ADDENDUM NO. 2

March 20, 2023

**LIBERTY AND WESTCHESTER INTERMEDIATE SCHOOLS -
ATHLETIC SITE PROJECTS
Chesterton, IN 46304**

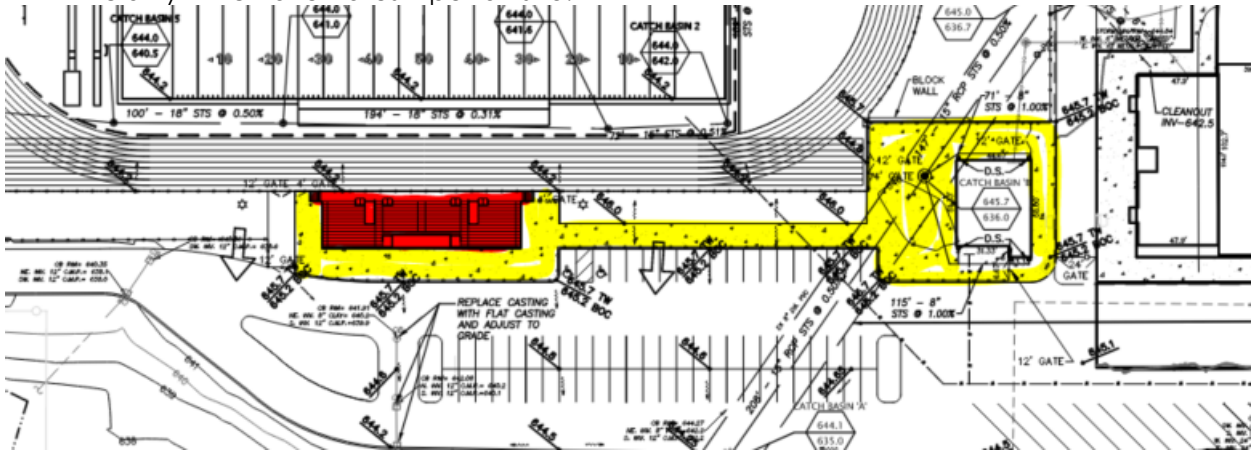
1. Sheet 3.2 states to “replace casting with flat casting and adjust to grade” please confirm what type casting is needed at these 3 locations.
2. C2.1 to mill existing asphalt, in some areas the elevation change is 2 feet. How would you like us to address milling these areas? Do we need to do a completely new asphalt section in these areas?

1. The required flat casting types shall be EJ1020 round open grate, or approved equal.
2. See above response.
